That he is a Vice President of Florida Power & Light Company,
the Licensee herein;

6. POWER DISTRIBUTION LIMITS

HOT CHANNEL FACTOR
NORMALIZED OPERATING ENVELOPE
(for steam generator tube plugging 22% and $F_q = 1.99$)

Figure 3.2-3a

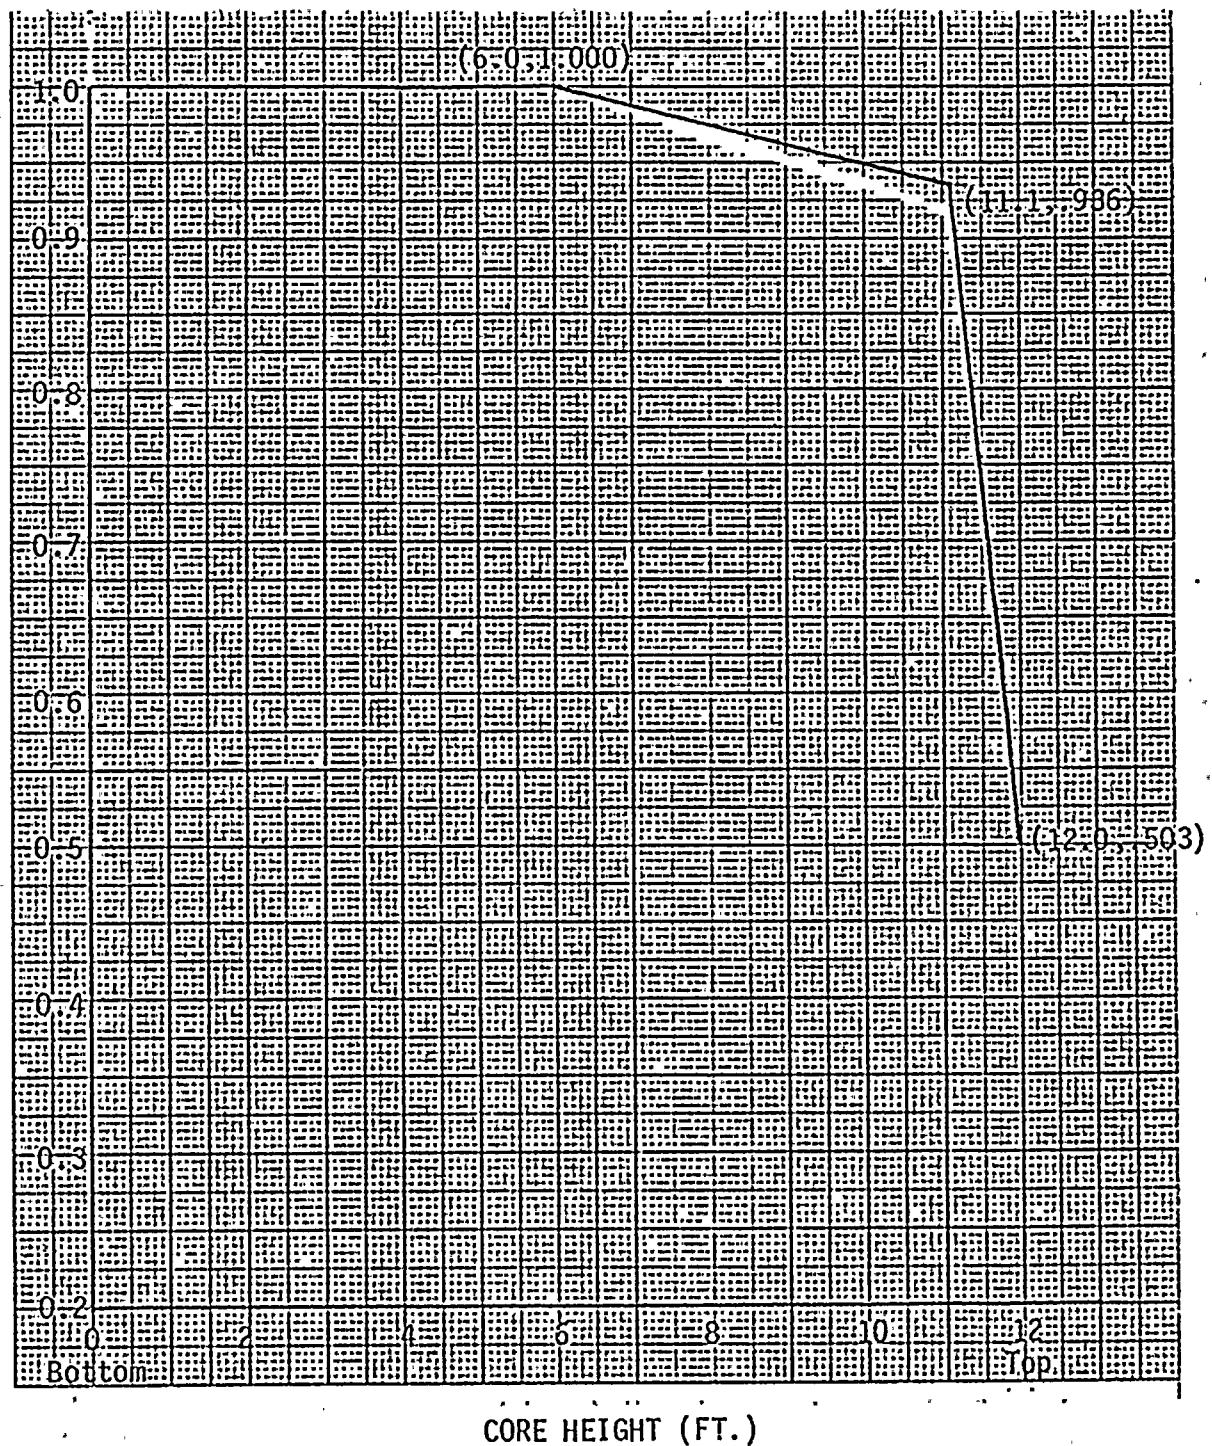
- (2) With steam generator tube plugging $\leq 22\%$, the hot channel factors (defined in the basis) must meet the following limits at all times except during low power physics tests:

Where P is the fraction of rated power at which the core is operating; K(Z) is the function given in Figure 3.2-3a; Z is the core height location of F_q .

FIGURE 3.2-3b

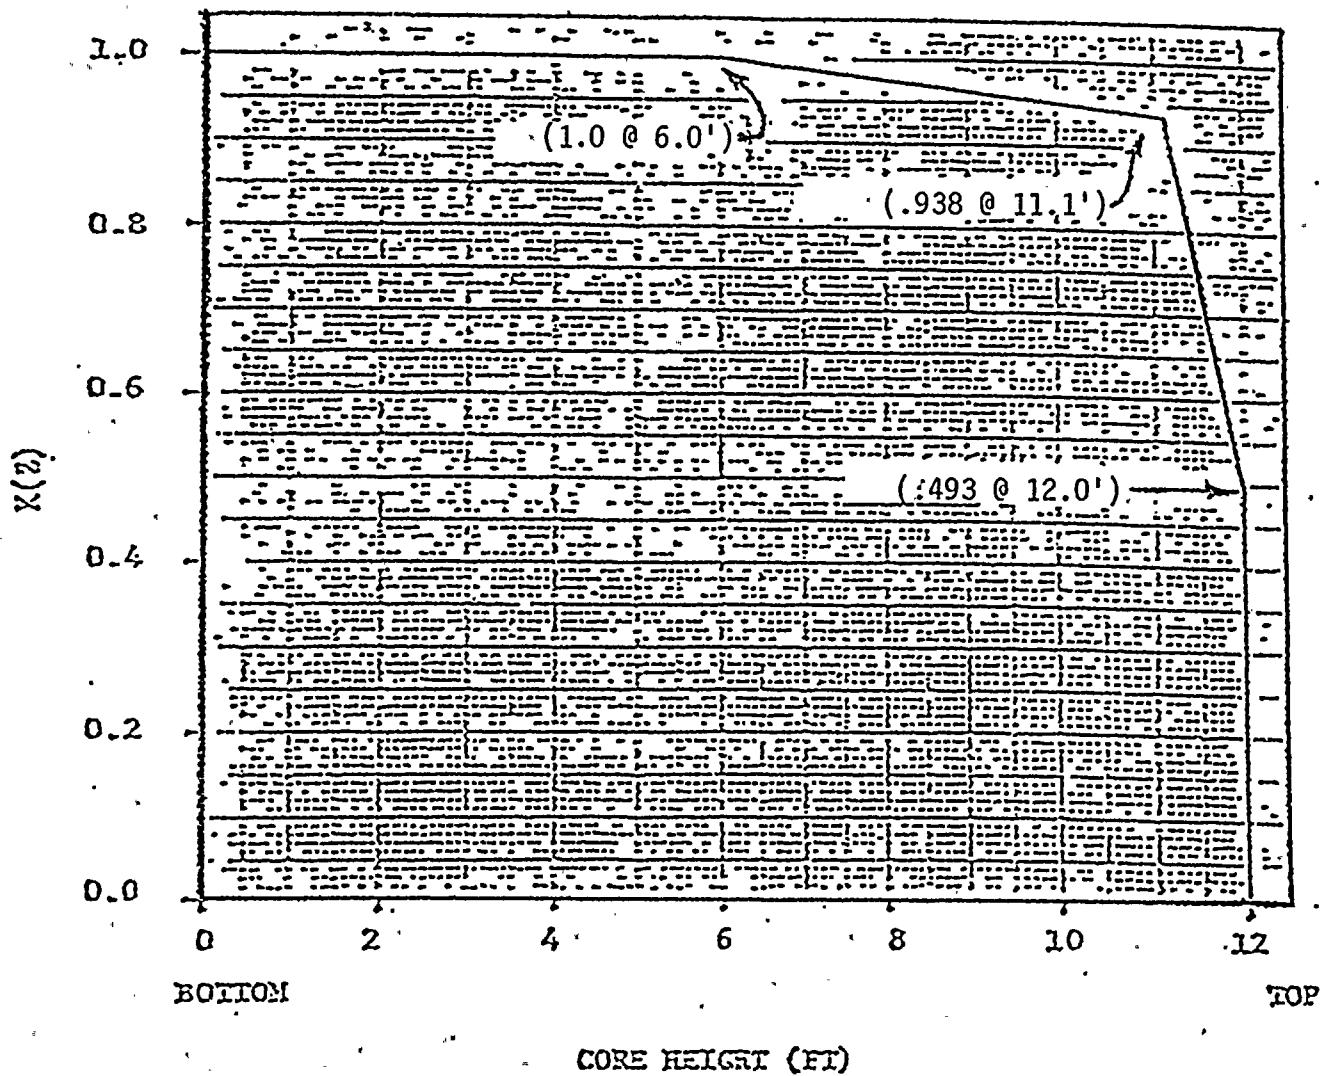
- (1) With steam generator tube plugging >22% and <25%, the hot channel factors (defined in the basis) must meet the following limits at all times except during low power physics tests:

Where P is the fraction of rated power at which the core is operating; K(Z) is the function given in Figure 3.2-3b; Z is the core height location of F_q .

HOT CHANNEL FACTOR-NORMALIZED
OPERATING ENVELOPE (FOR STEAM
GENERATOR TUBE PLUGGING $\leq 25\%$ and $F_q = *$)

* To be supplied based on results of revised ECCS analysis for 25% steam generator tube plugging.
